ADDENDUM NUMBER 2

MILWAUKEE COUNTY RESEARCH PARK ENTRANCE  
LANDSCAPING AND IRRIGATION  
10437 INNOVATION DRIVE  
WAUWATOSA, WI

Project No. O223-13628

Date of Addendum: July 01, 2013

**17** Wall Section  
 $1/2" = 1'-0"$

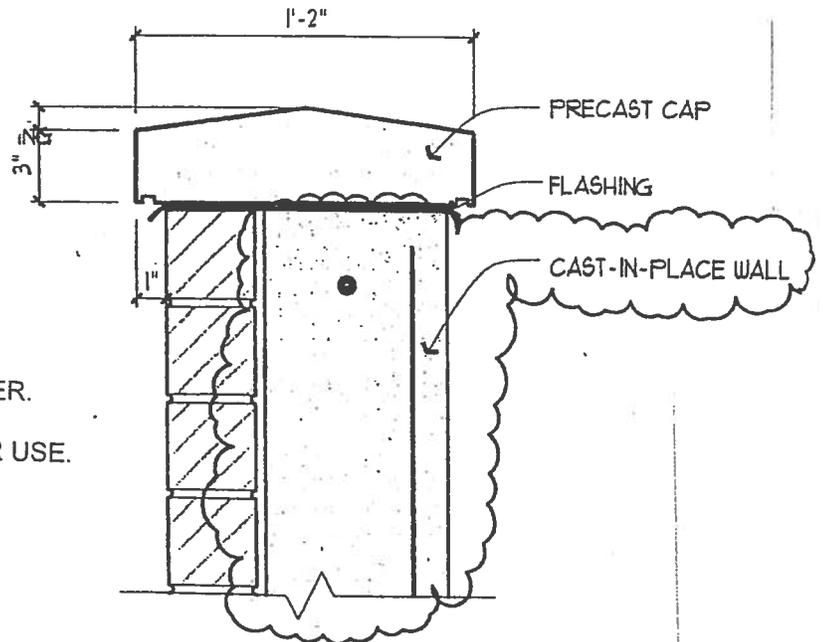
**Section 04300, Wall Detail Drawing**

**Change:** Delete wall detail drawing bound in project manual Section 04300 and replace with wall detail drawing attached to this Addendum No. 2. The height of exposed face of wall varies. The elevation of the bottom of the footings can be stepped. Maintain a bury depth of minimum 4'-0" from finish grade at face of wall to bottom of footings.
